133 EAST 8<sup>TH</sup> AVENUE (COMPLETE APPLICATION)  
DE414511 - ZONE C-3A

**DEVELOPMENT PERMIT STAFF COMMITTEE MEMBERS**

**DEVELOPMENT PERMIT STAFF COMMITTEE RECOMMENDATION: APPROVE**

**A-1.04**

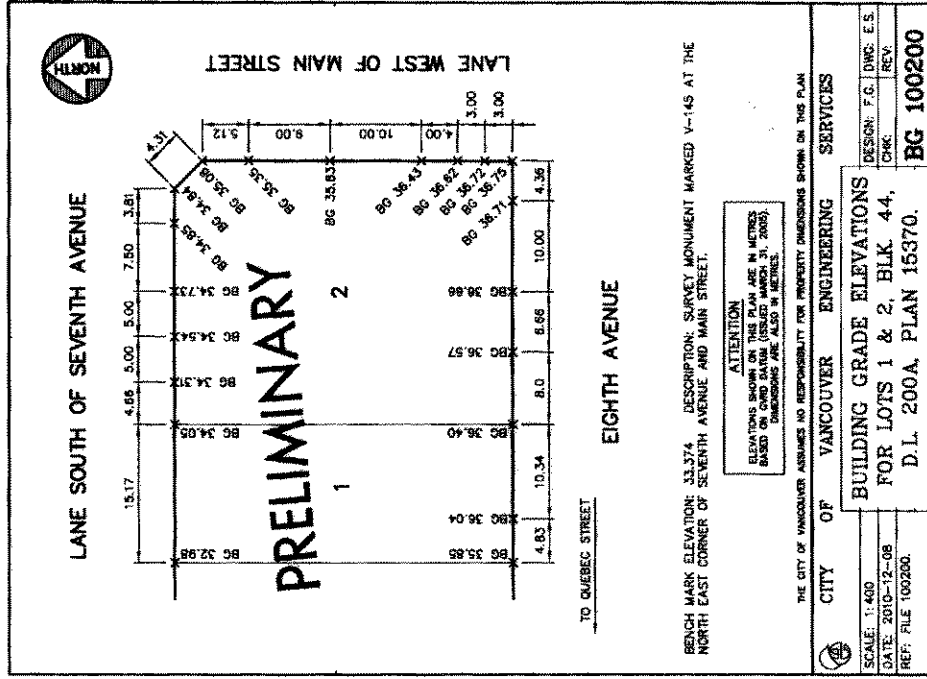
A.1.2 an up-to-date copy of the City building grades plan is to be submitted;

**Note to Applicant:** Correct City building grades are to be shown on the site plan and elevation drawings. Detailed floor and roof elevations should also be shown for each floor and roof level in the building, as related to the existing grades on site.

**A-4.01**

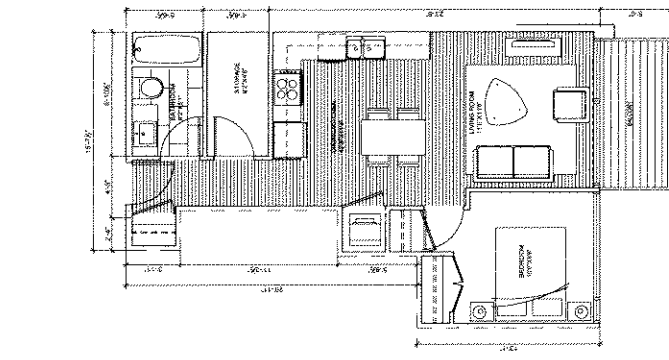
**Note to Applicant:** Dwelling unit types with regard to the number of bedrooms in each unit should be identified on the submitted floor plans. The dwelling unit specified as a one-bedroom unit between Grid Lines 4 and 6 on the third through sixth storeys appears to be a Studio unit.
